Staff Evaluation Second Review

Application: Timothy Schmidt, Schmidt Planned Unit Development – CONTINUATION: Seeking recommendation to the City Council for a concept plan for a 4 Lot single family dwelling planned unit development located at 182 North 600 East.

Application Number: 26-010
 Preparation Date: June 3, 2026
 Applicant Name: Timothy Schmidt
 Property Owner: Timothy Gordon Schmidt
 Property Address: 182 North 600 East
 Parcel Number: 01-013-0030
 Parcel Area: 3.22 Acres

CONCEPT PLAN

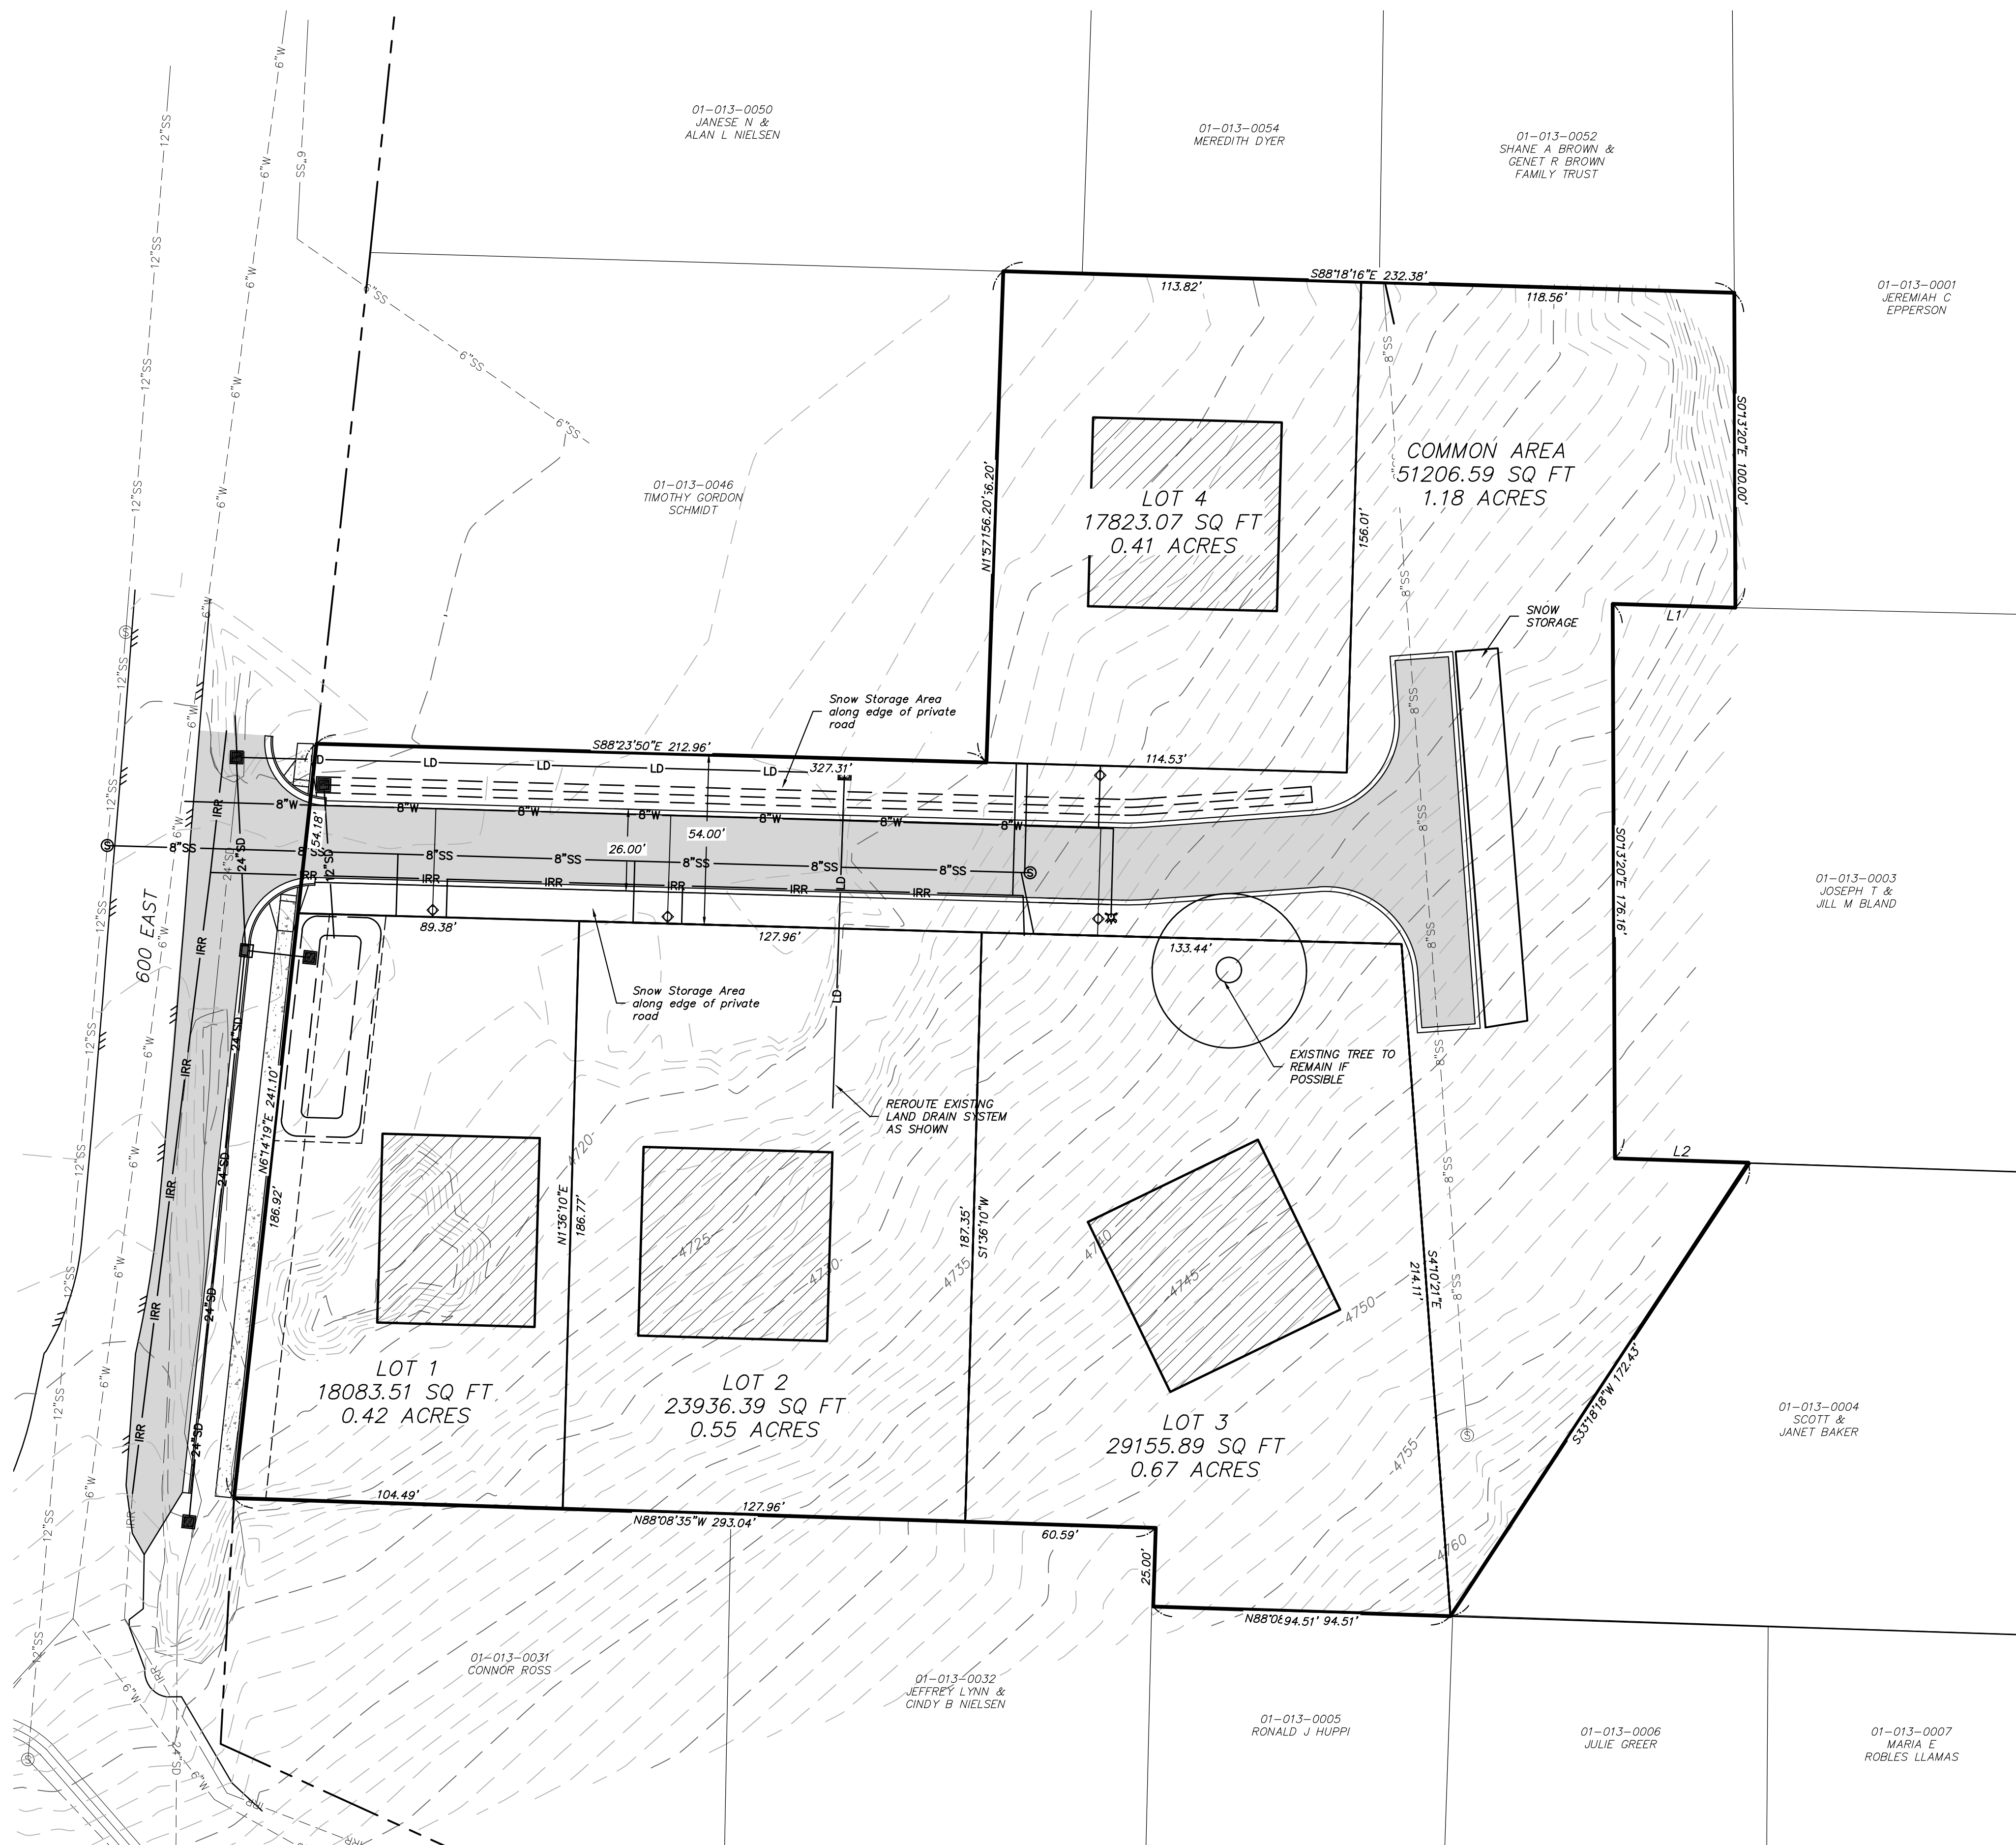
1. Staff supports the updated concept plan as submitted with the private road, hammerhead, and dedicated common area of 1.18 acres.
2. The application submitted is *Schmidt Planned Unit Development* and the draft Homeowners Association Declaration of Covenants, Conditions and Restrictions is titled *Vernon Hills*. Applicant verify the desired title of the Planned Unit Development.

1. The grade of the private road cannot exceed 10% grade and the cross slopes, and cross slope of the hammerhead does not exceed 2% grade.
2. The private road will require "No Parking–Fire Lane" on each side of the private road and sign comply with IFC 2021 D103.6 Signs. Type "D". Show location of sign on site plan at the west entrance of the private road.

- b. The land drain proposed along the North edge of the driveway is a significant concern. The introduction of land drains to storm drain infrastructure eliminates capacity from the existing and proposed systems due to the need to convey groundwater continually. This is especially evident in the case of retention ponds. Any land drain upstream of a detention pond, such as the one proposed in this concept plan, will fill the detention volume in the pond set aside to allow for infiltration of smaller storms and maintain a constant pool of water in the bottom of the pond. The connection of land drains to storm water infrastructure is generally not prudent Engineering design and should be considered prior to acceptance.

- b. The proposed infrastructure does not provide sidewalk, curb and gutter, or an appropriate turnaround radius.
 - c. The location of the driveway on Lot 4 is unknown and would conflict with the proposed swale on the north side of the roadway.

1. Water service for lot 4 should be run to the other side of swale to the north. Services should not run parallel with the main line.
2. Fire Hydrant will need its own valve and 6" fire line. The water department prefers all fire lines to be short crossing street sections.
3. Both water mains will require a tie-in feed valve in public ROW. Both water mains will need a 2" blow off at dead ends in utility easement. All hookups on both water mains need to be properly spaced to manufacture specs.
4. Both irrigation and culinary meter bases should not be in driveways. Are there any house plans showing future build models to determine where locations are?

We have now provided 1.18 acres of common space for the neighborhood to enjoy, based on the city council discussion, they believe we can lower the amount of amenities/open space due to our lower density.

We will provide no parking signs/stop sign as needed

We are planning on preserving the existing tree on site if possible, we are ensuring that the existing spring water still gets into the existing ditch along the road. We are also preserving the views of the upper lots by keeping the newer houses lower.

Parking for each house will be on their own driveway. Parking will not be allowed on the private street.

At this time we are not planning on any fencing/walls. Each homeowner in the future will have the option to put up their own fencing. Trash will be collected through the use of garbage cans that will need to be brought to the public street for collection.

CONCEPT PLAN

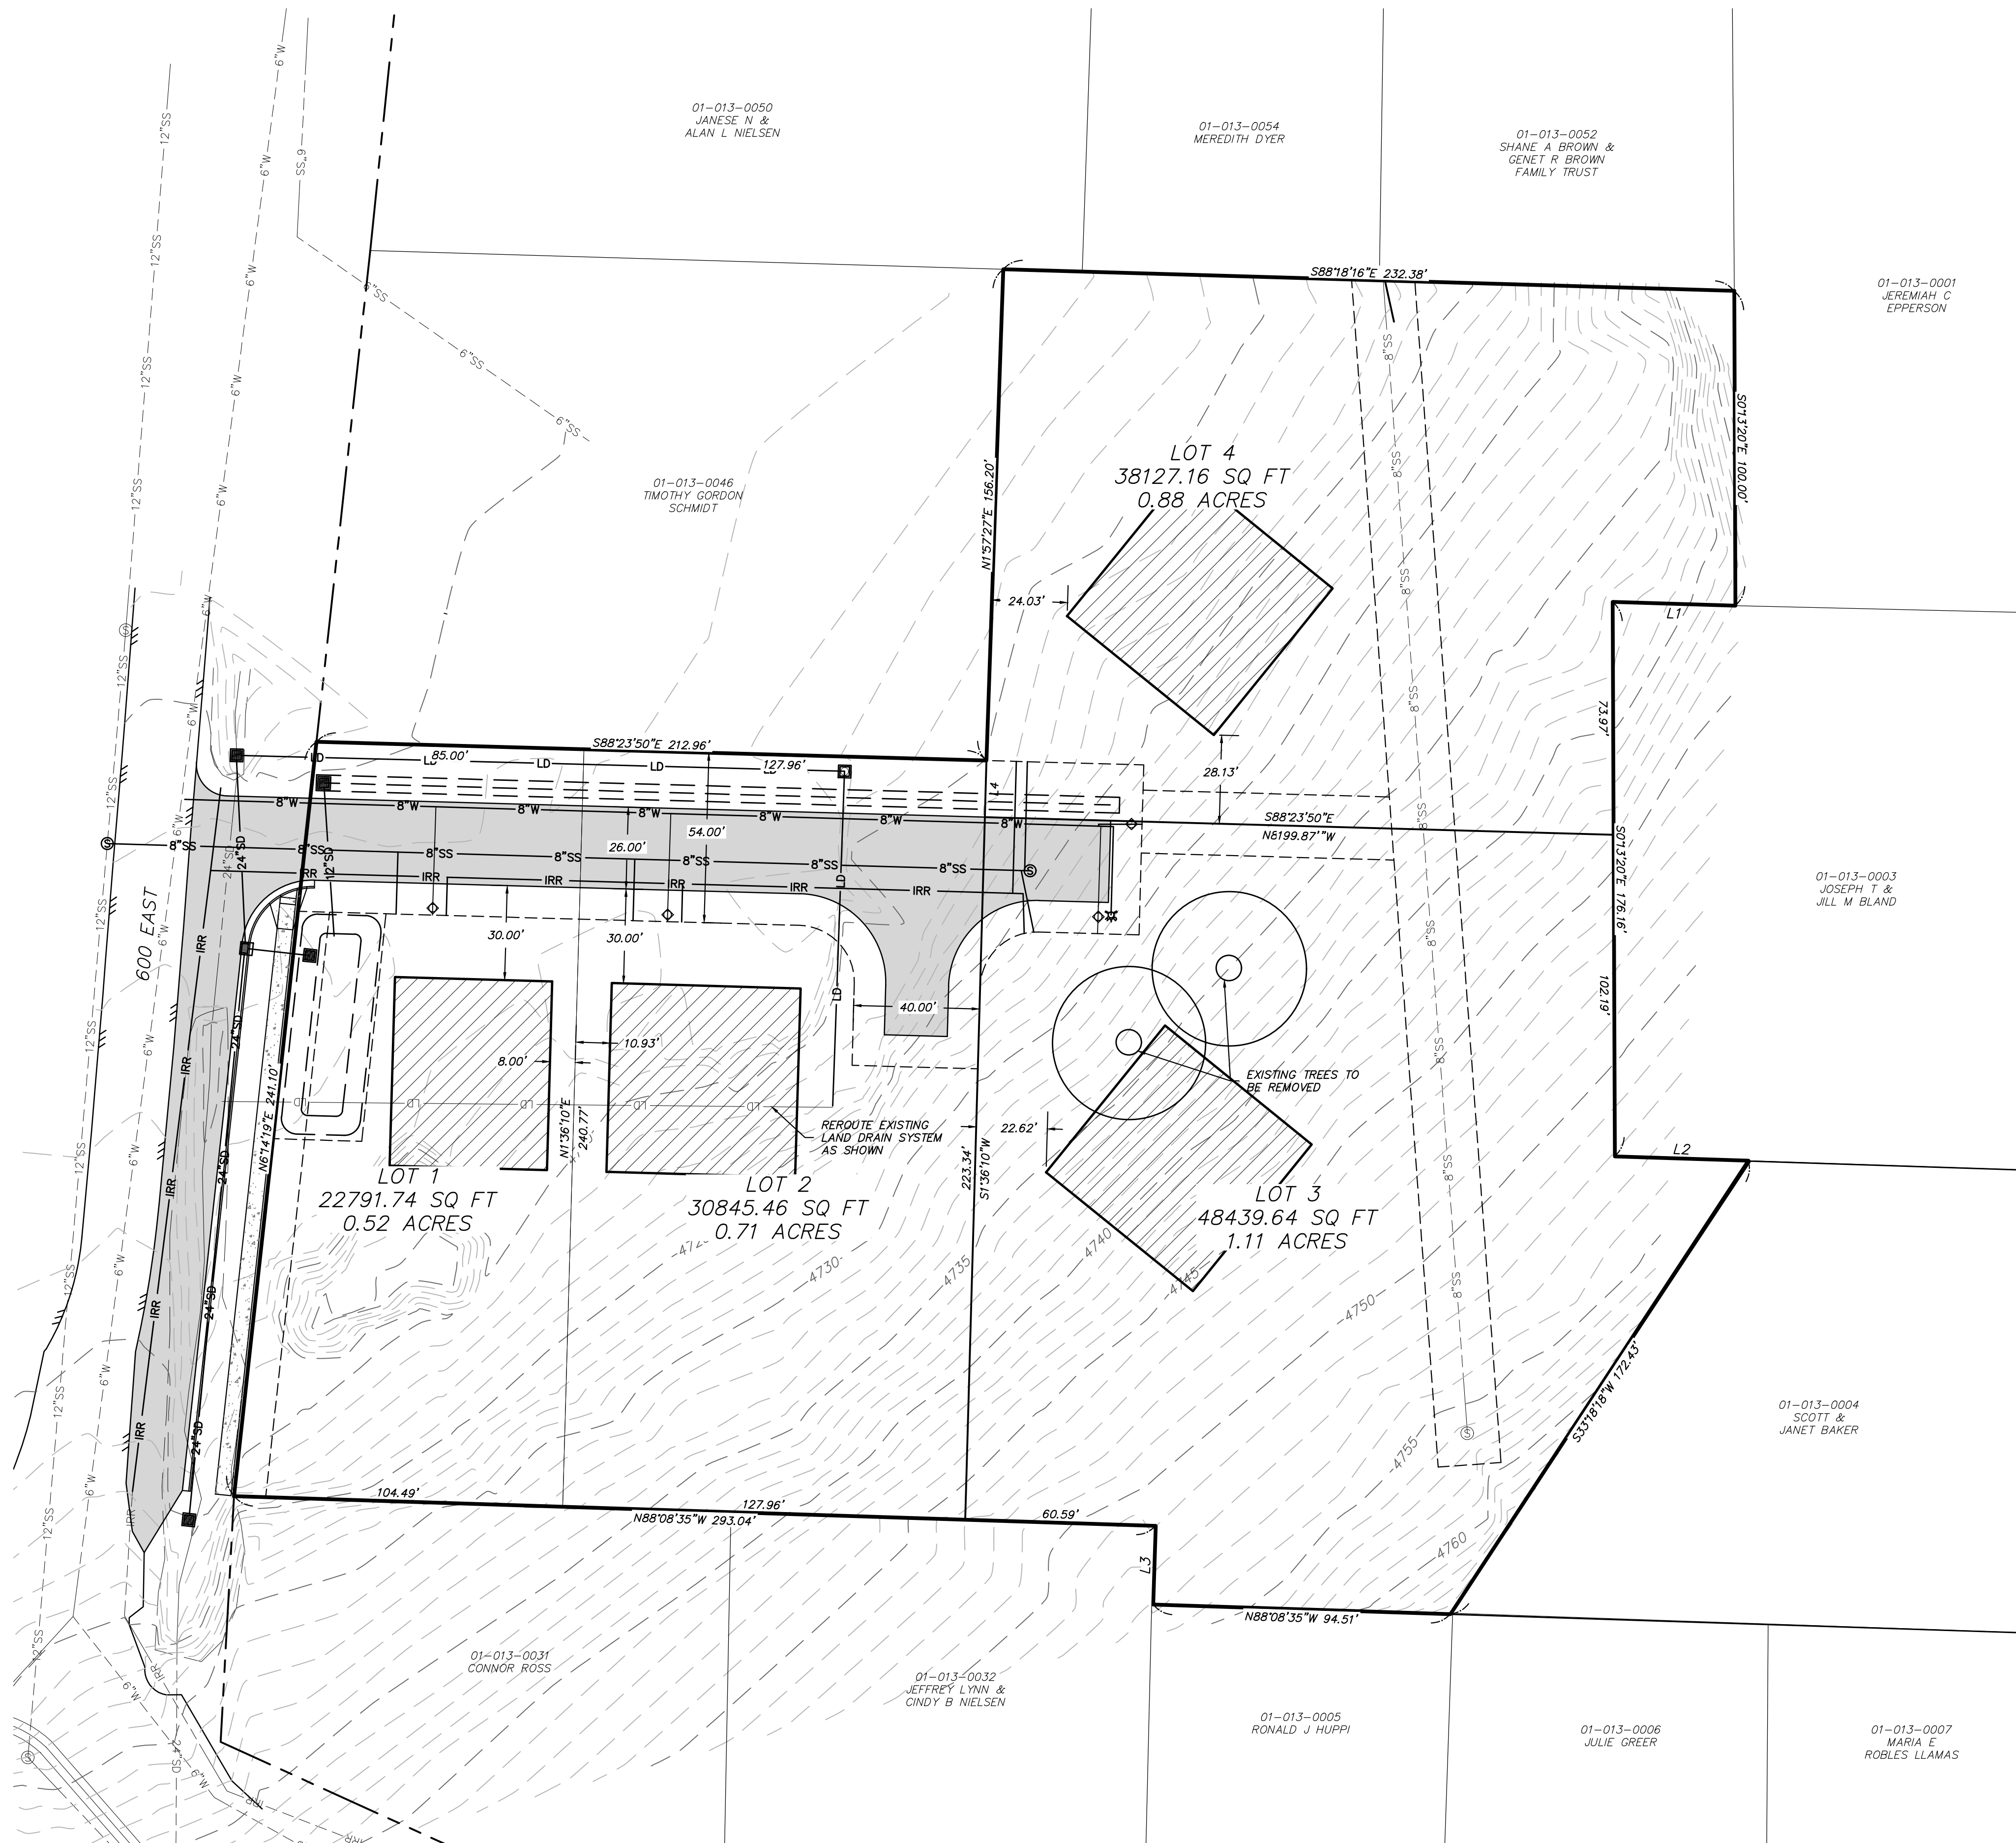
4. Other Consideration:
 - a. The proposed design creates three lots that do not front a public right of way but are only accessible through an access easement provided by the developer.

1. What is the grade of the road? Not to exceed 10 percent in grade.
